# Recall Bulletin

## F/CMVSS NONCOMPLIANCE RECALL

**SUBJECT:** Passenger Side Instrument Panel Performance

**MODELS:** 2009-2014 Chevrolet Express  
2009-2014 GMC Savana  
1500 Series Equipped with Passenger Side Airbag (AK5))

3804499

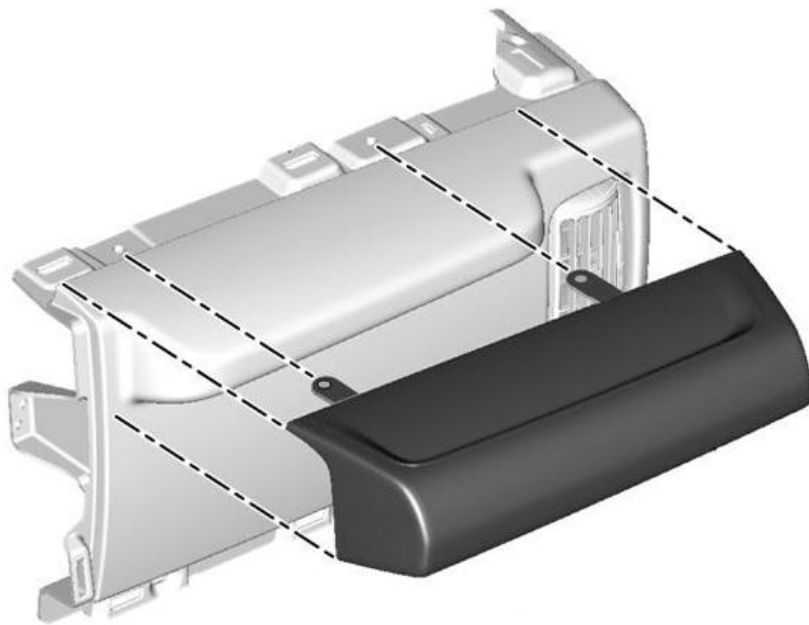
2. Remove the upper two screws that attach the instrument panel pad to the instrument panel bracket.

3. Inspect the brow assembly before installation to ensure the energy absorbing material is present.

4. Install the brow assembly to the instrument panel.

5. Secure the brow assembly to the instrument panel using the two screws that were previously removed. Tighten the screws to 3 N-m (27 lb in).

- Using the brow assembly as the template, drill two holes using an 8 mm (5/16 in) bit. The depth of the hole should be no more than 30 mm (1.25 in) deep.

3804499

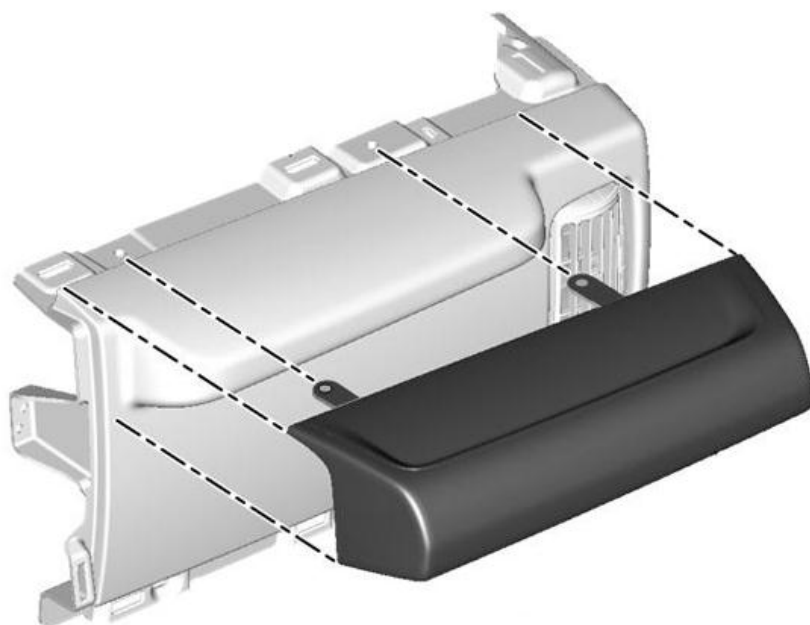
2. Remove the upper two screws that attach the instrument panel pad to the instrument panel bracket.

3. Inspect the brow assembly before installation to ensure the energy absorbing material is present.

4. Install the brow assembly to the instrument panel.

5. Secure the brow assembly to the instrument panel using the two screws that were previously removed. Tighten the screws to 3 N-m (27 lb in).

- Using the brow assembly as the template, drill two holes using an 8 mm (5/16 in) bit. The depth of the hole should be no more than 30 mm (1.25 in) deep.
